Model Error Resolution Document

1. Document Number:	MDL-NBS-HS-000010	2. Revision/Addendum:	03/01	3. ERD:	01
---------------------	-------------------	-----------------------	-------	---------	----

4. Title:	Site-Scale Saturated Zone Transport
-----------	-------------------------------------

Figure A-49[b]. Thorium Sorption Coefficients on Tuff versus Calculated Final Thorium Concentration in Solution

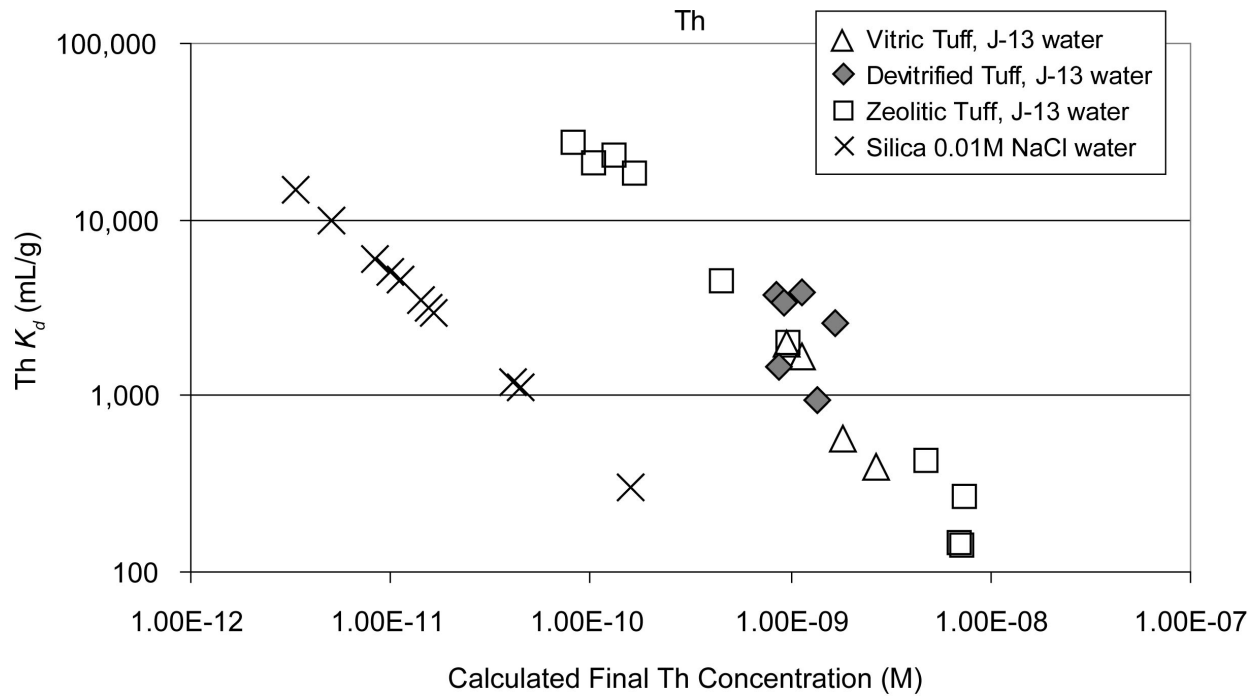
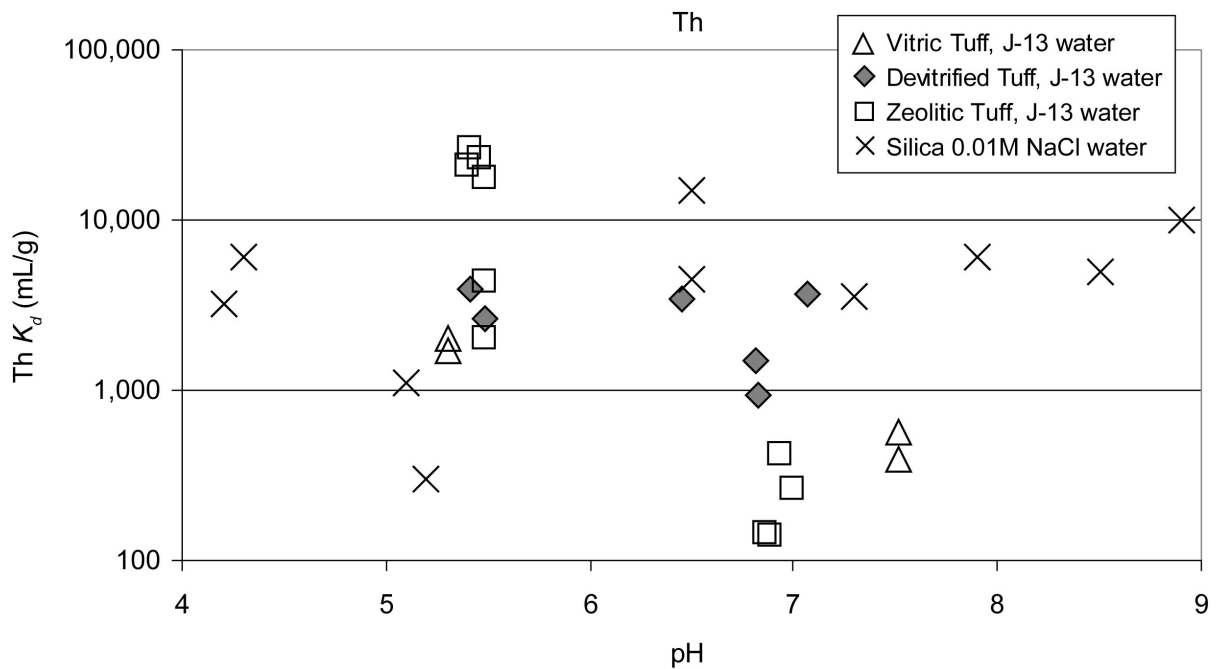
- Correction of the rock type for sample G1-3116 from devitrified to zeolitic. Hence, Section A7.9.1 and Figures A-49 and A-50 were revised to reflect these changes, as discussed below. Silica samples are added to Figure A-49. The calculated Th concentrations for the silica are lower than those of vitric Tuff, Devitrified Tuff, and Zeolitic Tuff, but K_d range is the same. The K_d distributions remain unchanged.

Figures A-49 and A-50 are replaced by the following, **and** the following two paragraphs added to the Section A7.9.1:

In Figure A-49[b], it is seen that the K_d values for silica, and zeolitic tuff generally span the same range, from about 1000 mL/g (for experiments with concentrations below the solubility limit of $\sim 3.2 \times 10^{-9}$ M at pH>6, as noted in Section A7.9) to above 10,000 mL/g. The data for devitrified tuff fall within this range also, although these data, with only 6 points, are much more limited. It is noted that the SZ model averages the K_d values over much larger spatial extent compared to the unsaturated zone (MDL-NBS-HS-000008 ERD02 [DIRS 177396]) and thus the units designated as devitrified in the SZ are likely to encompass local regions with higher zeolitic content. Hence, it is justified to use the same uncertainty distributions in the SZ for thorium K_d s for both devitrified and zeolitic tuffs. For these reasons, the uncertainty distributions for thorium K_d s in the SZ are not modified, in contrast to the treatment in the unsaturated zone (MDL-NBS-HS-000008 ERD02 [DIRS 177396]).

Figure A-53[b]. Uranium Sorption Coefficients on Devitrified Tuff versus Calculated Final Uranium Concentration in Solution

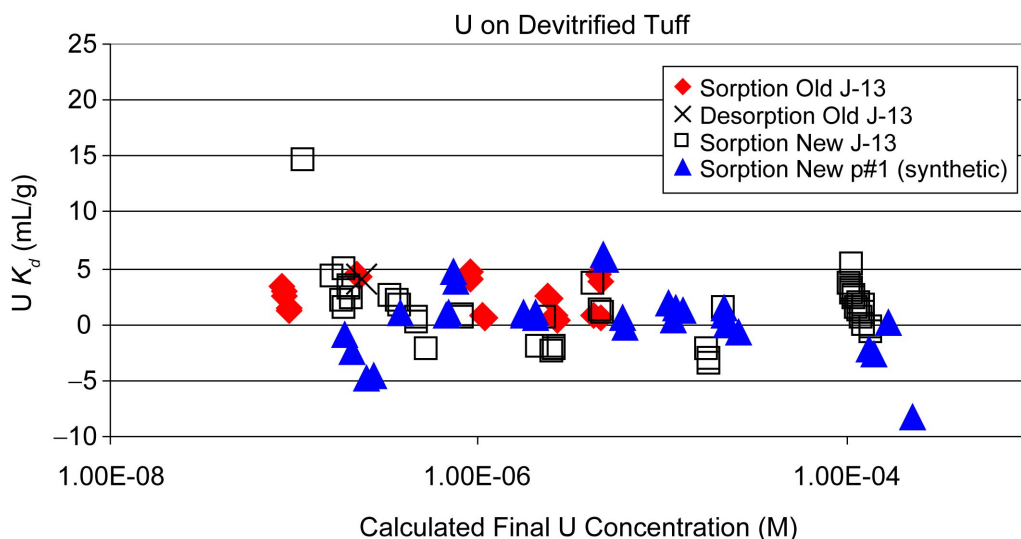
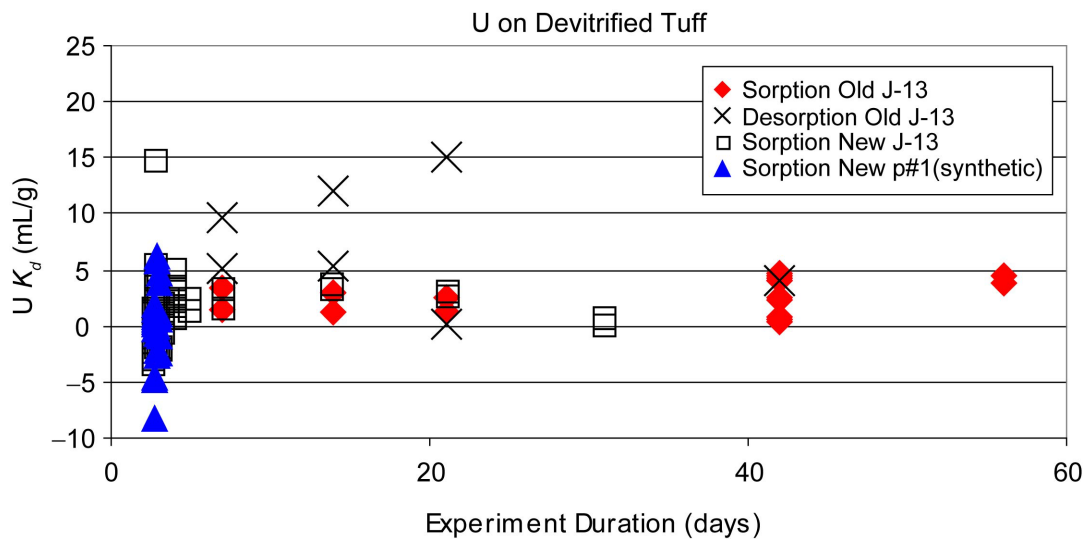
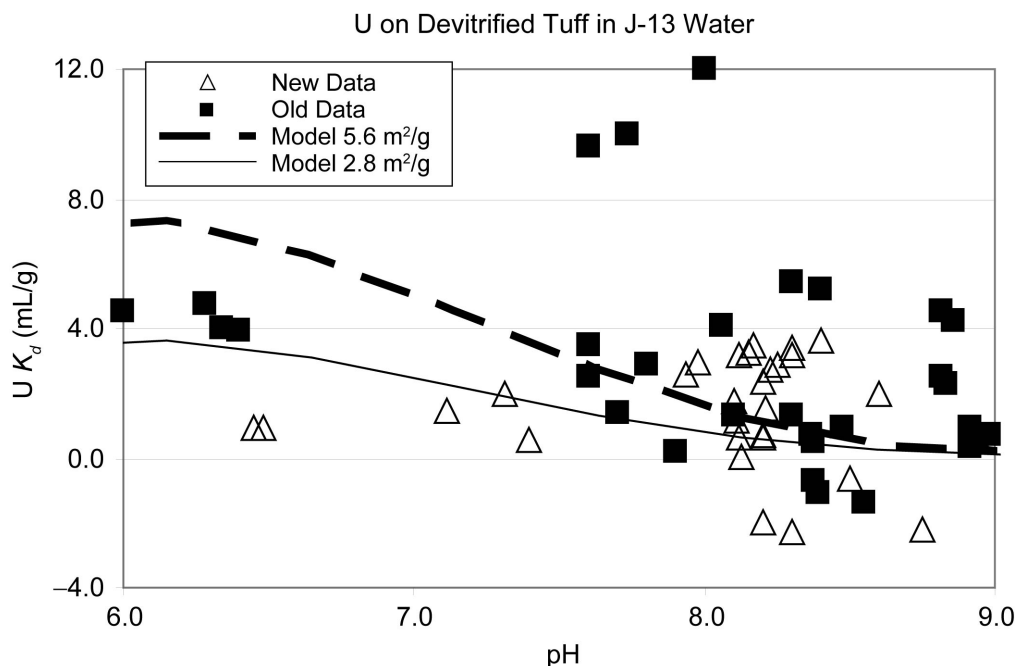
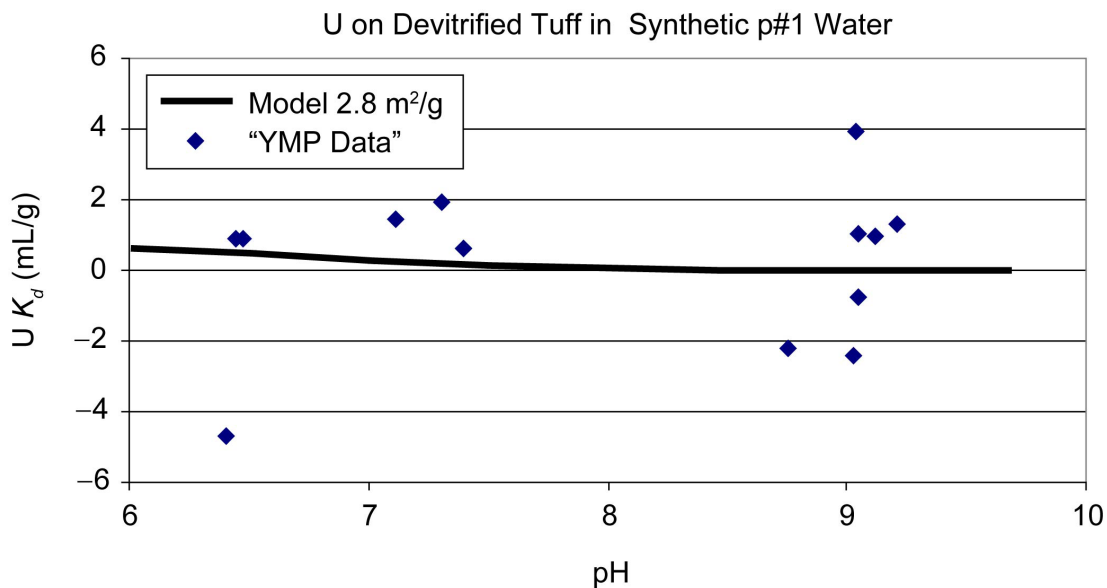
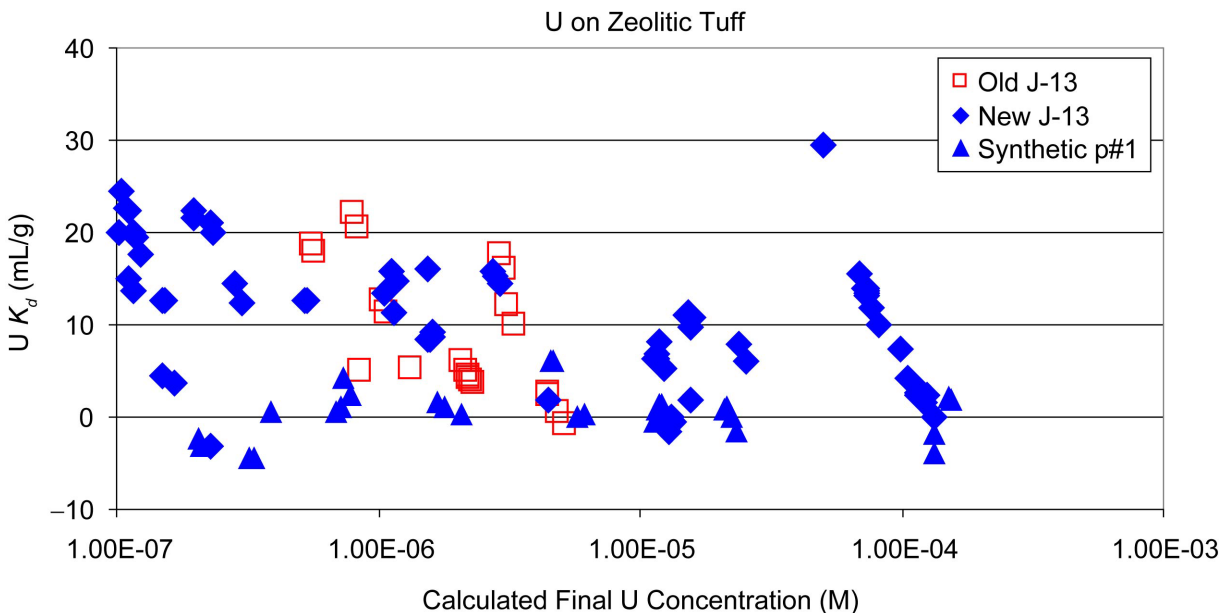
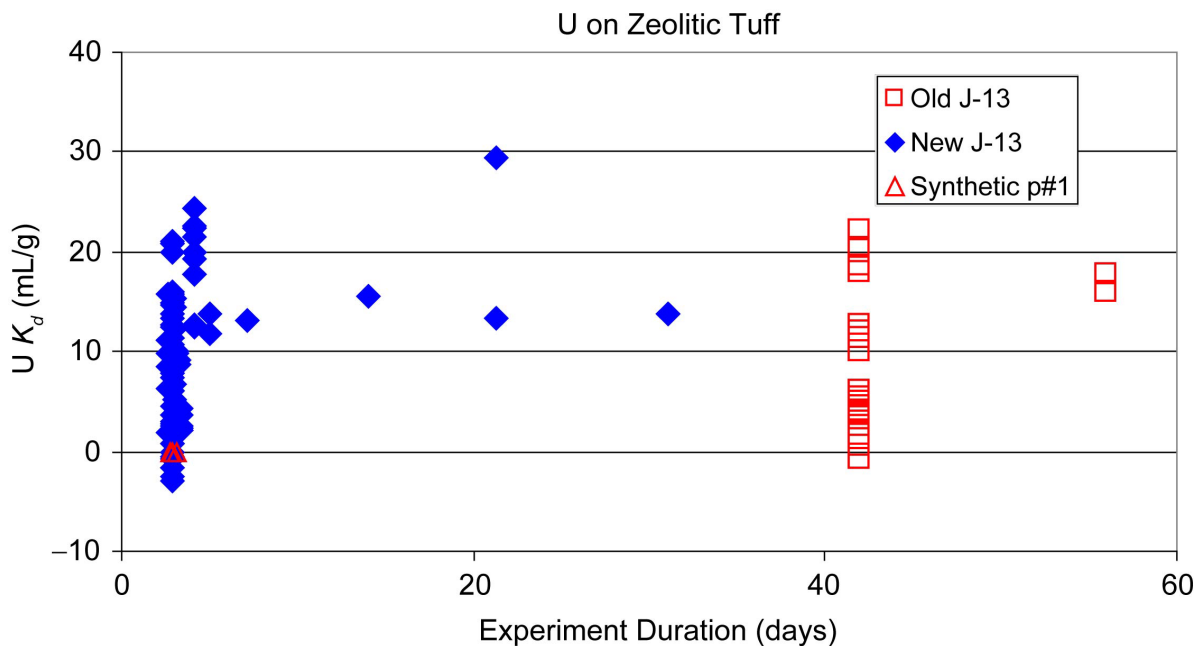
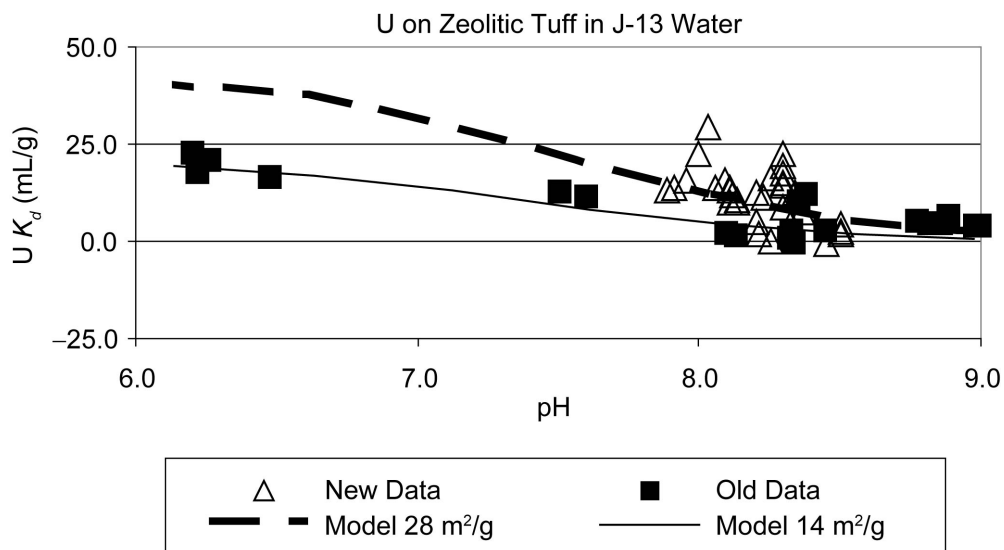
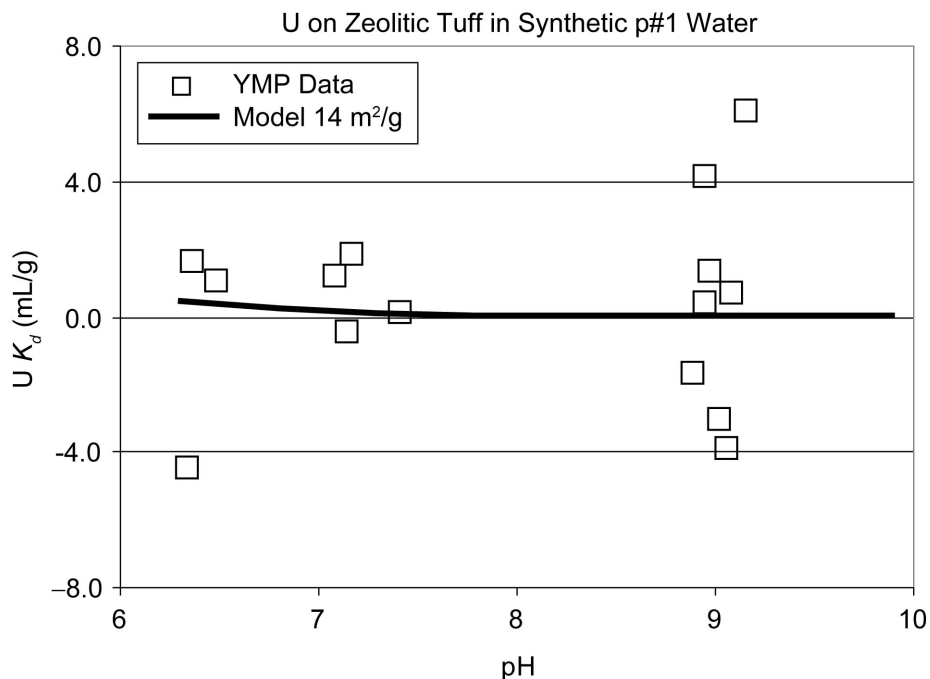
- Correction of the rock type for sample G1-2698 from devitrified to zeolitic. Hence, Sections A7.11.1 and A7.11.2, as well as Figures A-53 through A-60, were revised. The K_d distributions remain unchanged.

- Figure A-60 was modified to include point (9.16, 6.01), which was mistakenly omitted in the previous version of the figure. Point (9.16, 6.01) falls within the range of the data already plotted in the figure. The text explaining Figure A-60 remains valid. The K_d distributions remain unchanged.

Figures A-53 through A-60 replaced by the following:

Figure H-1[b]. Barium Sorption Coefficient on Zeolitic Tuff in J-13 Well Water versus Calculated Final ^{133}Ba Solution Concentration

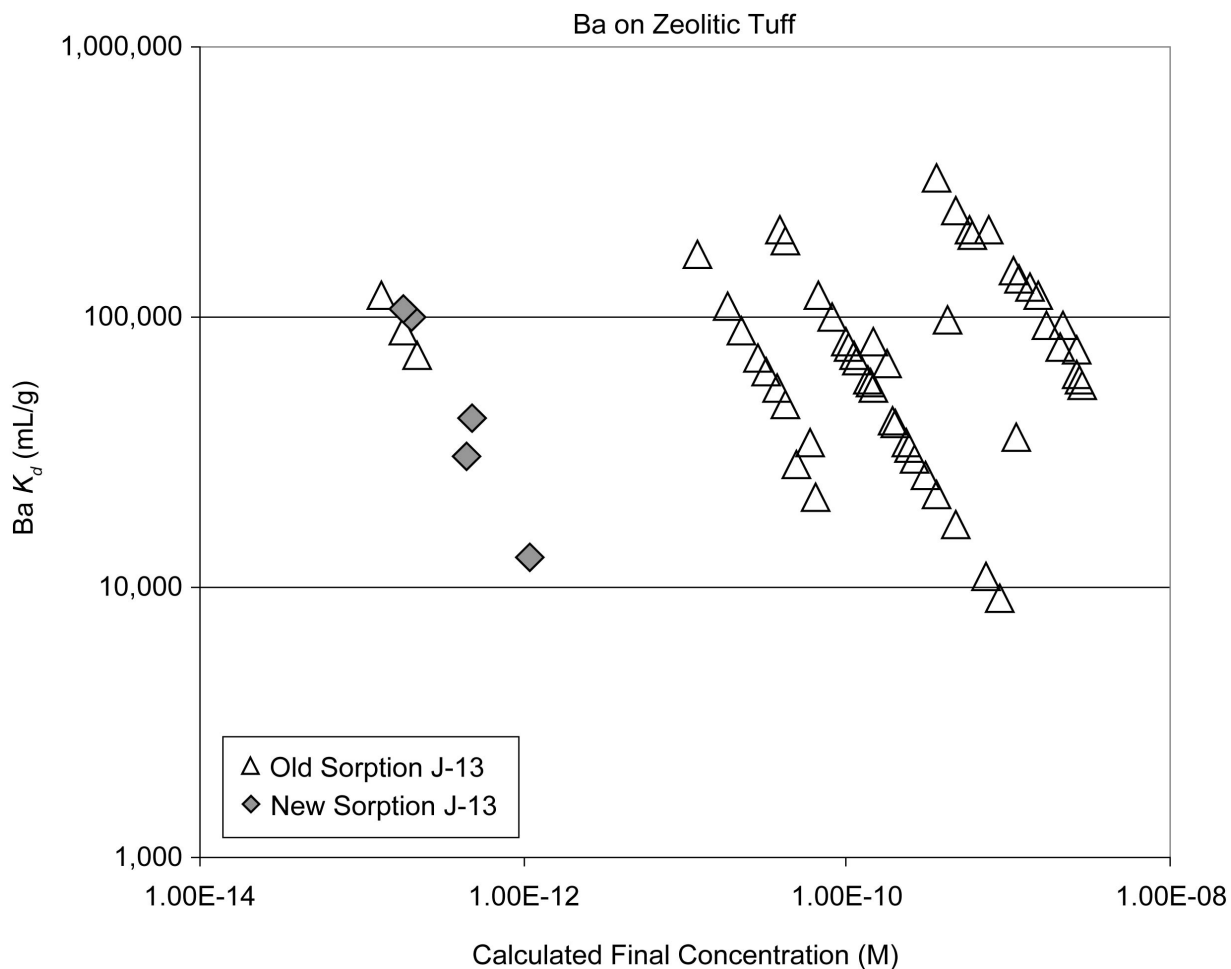
The following additional error was noted in Figures A-35 and H-1: the point with the highest value for “Sorption J-13 New” data, denoted by open squares in the figures, is not listed in the source DTNs.

Two examples are cited of comparisons of qualified and unqualified datasets for elements-of-interest, the first is barium representing radionuclides that sorb by ion exchange and the second is uranium representing radionuclides that sorb by surface complexation. The first example is for barium sorption coefficients on zeolitic tuff in J-13 well water. Qualified and unqualified data points for sorption coefficients and final solution concentrations are shown in Figure H-1[b].

Figure A-37[b]. Selenium Sorption Coefficients on Devitrified Tuff versus Experiment

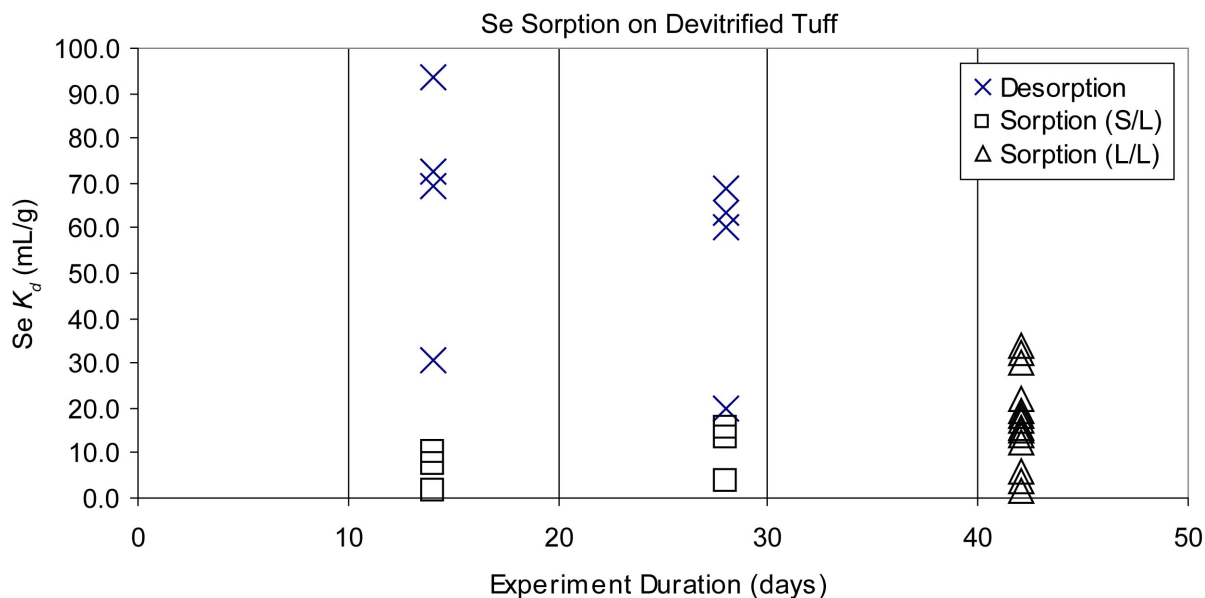
DTN: LA0702AM831341.001 [DIRS 179306] was superseded by DTN: LA0802AM831341.002 [DIRS 185081] to revise two data values attributed to transcription error and to revise the rock type classification of the samples G1-2233, G1-2289, G1-3116, G2-0547, GU3-1531, and GU3-433. The entries corresponding to DTN: LA0702AM831341.001 [DIRS 179306] in Table 4-1[a] and Section 9 of MDL-NBS-HS-000010 REV 03 AD 01 were changed. Figures A-36, A-37, A-39, and A-40 in MDL-NBS-HS-000010 REV 03 AD 01 were replaced.

The discussion in Section A7.7.1 of MDL-NBS-HS-000010 REV 03 AD 01 was modified and Figures A-36 and A-37 were replaced. Also, the discussion in Section A7.7.2 was modified and Figures A-39 and A-40 were replaced. The following subsections show the corrected text and figures:

Figures A-36 and A-37, and the first two paragraphs of Section A7.7.1 are replaced by the following:

Although data from the superseding DTN, plotted in Figure A-37[b], are different from those plotted in the previous version of the figure, the text explaining Figure A-37[b] remains valid. The K_d distribution remains unchanged
